JOB: PUBLIC SERVICE OF COLORADO PLATTEVILLE, COLO.	
CUST: BROWN BOVERI ELEC.	PO: R-00571
DATE: 79-89095	BY: S.W. 10-12-62
TITLE: BUS DUCT LAYOUT AND LOCATION OF BUS DUCT SUPPORTS	
DWG. NO: CN-1605-SK-24	
SHEET: 05

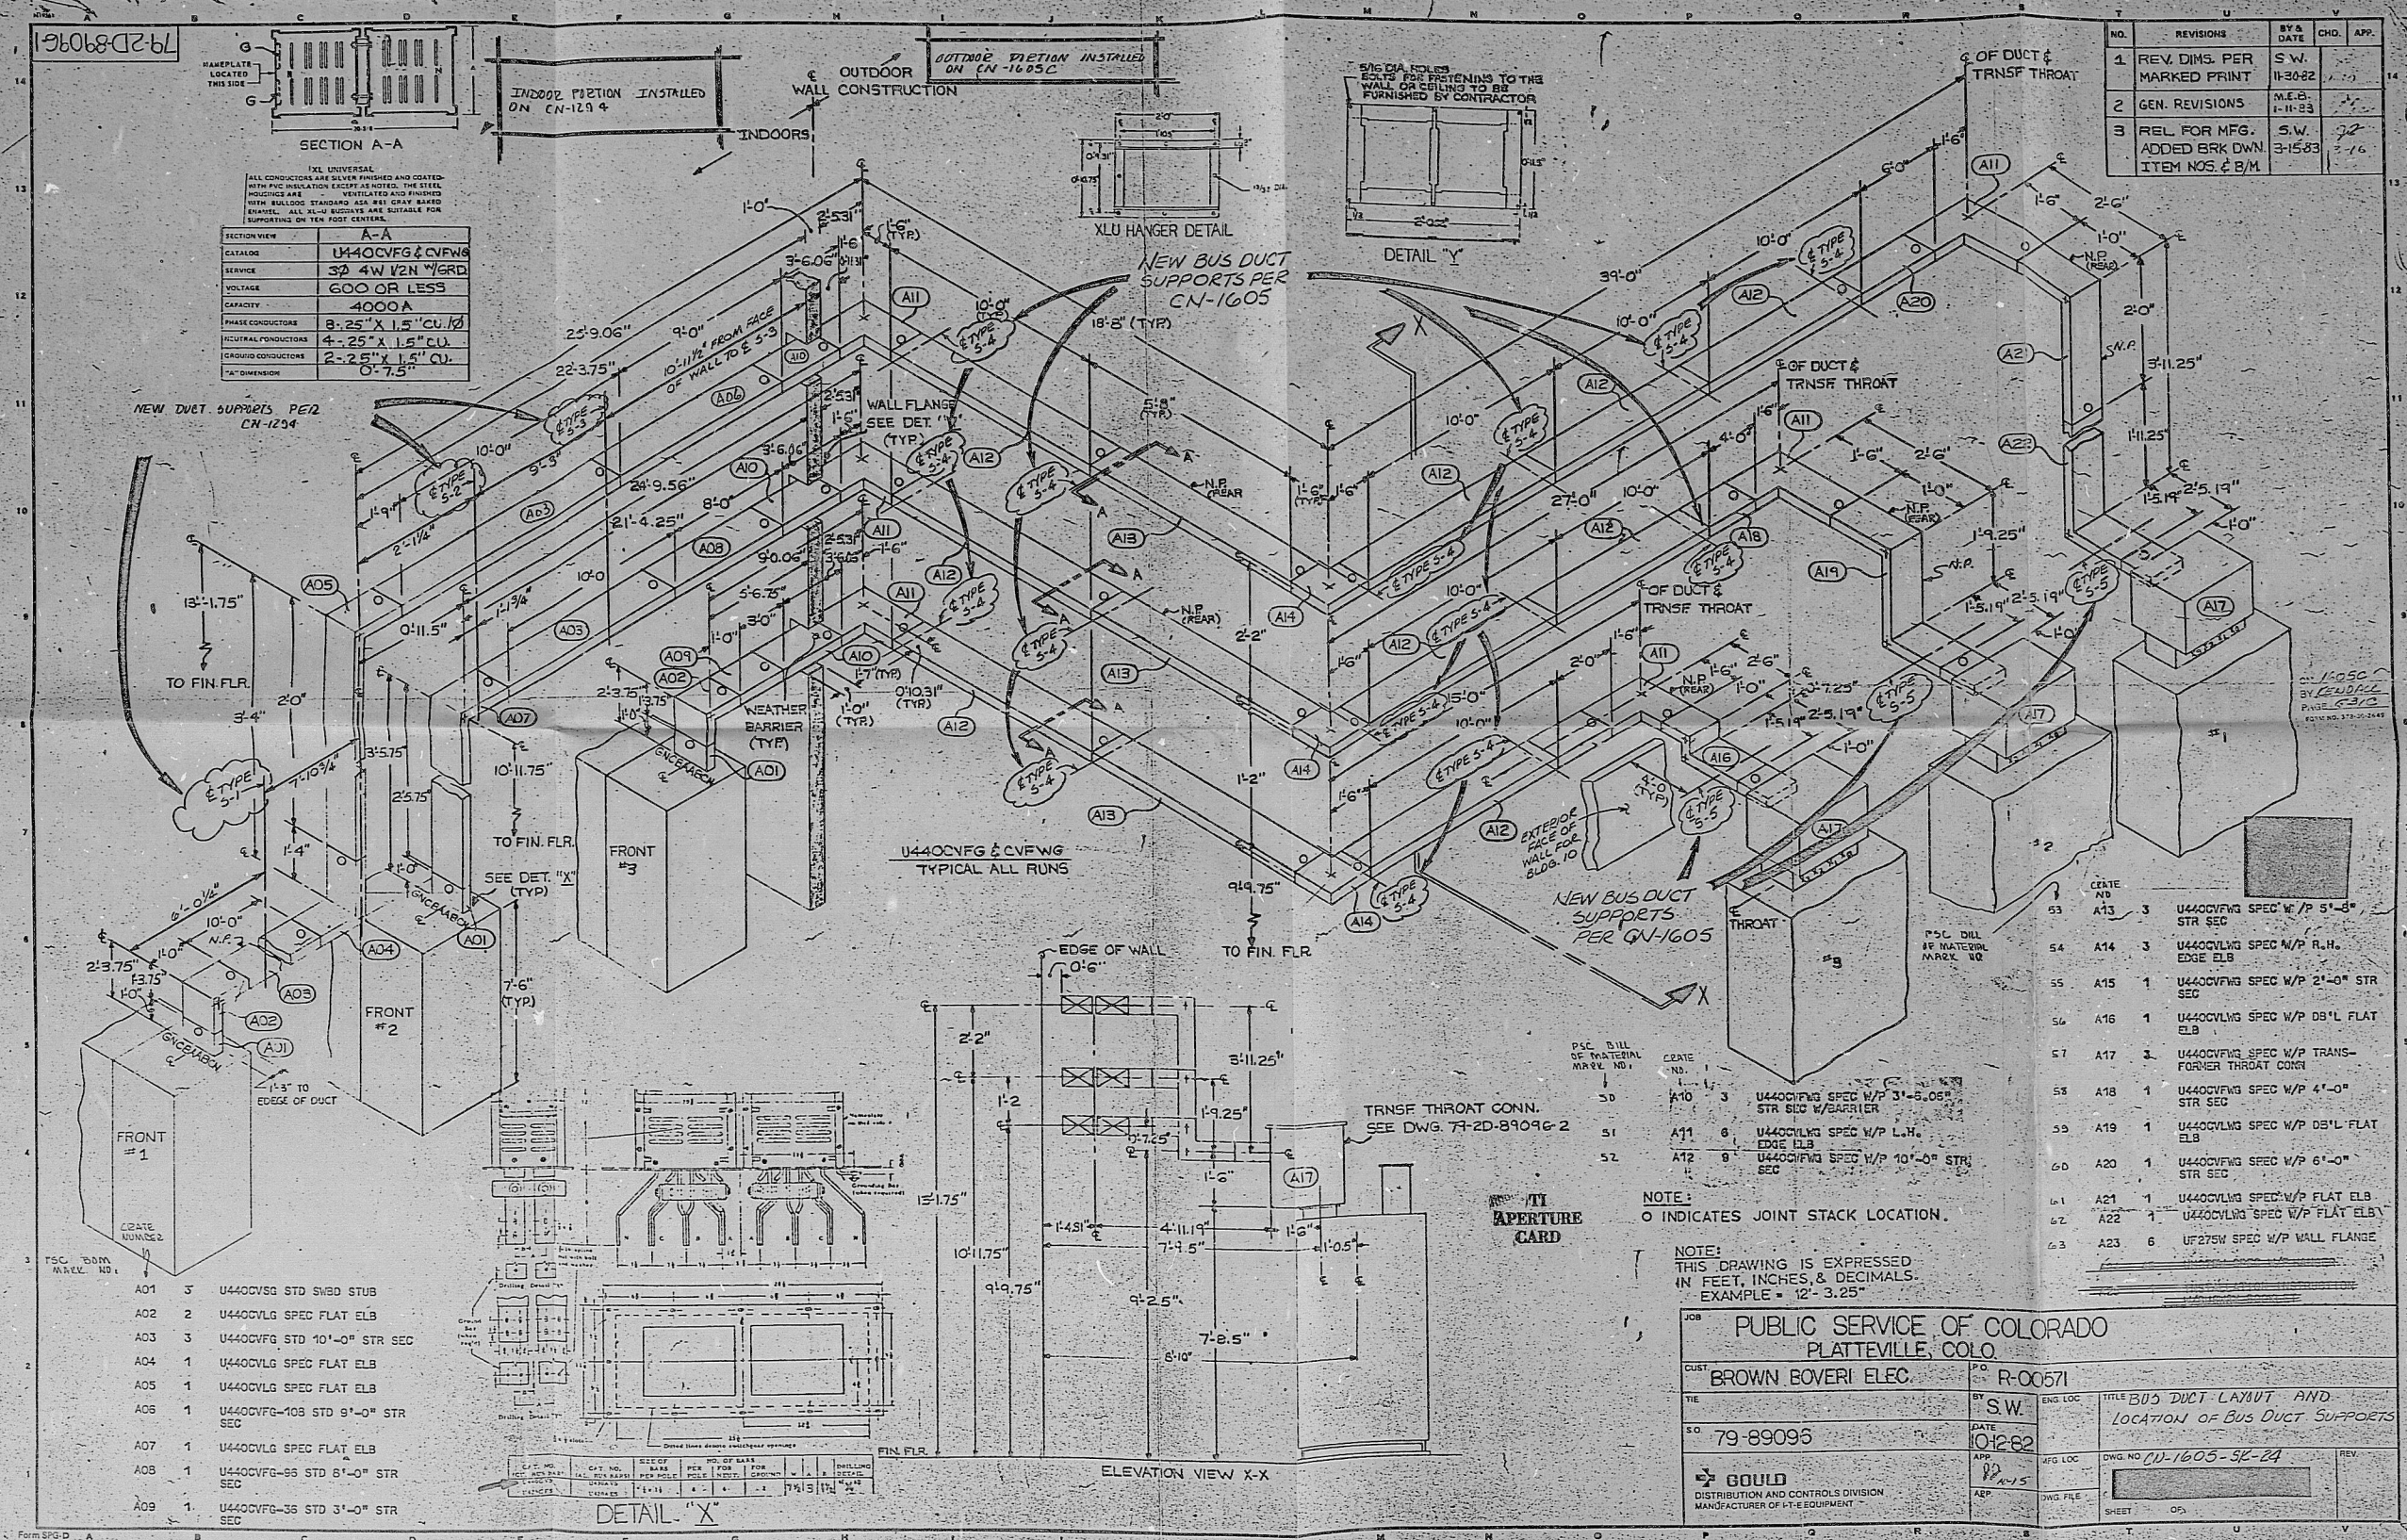
NEW DUCT SUPPORTS PER CN-1234

NEW BUS DUCT SUPPORTS PER CN-1605

NEW BUS DUCT SUPPORTS PER CN-1605
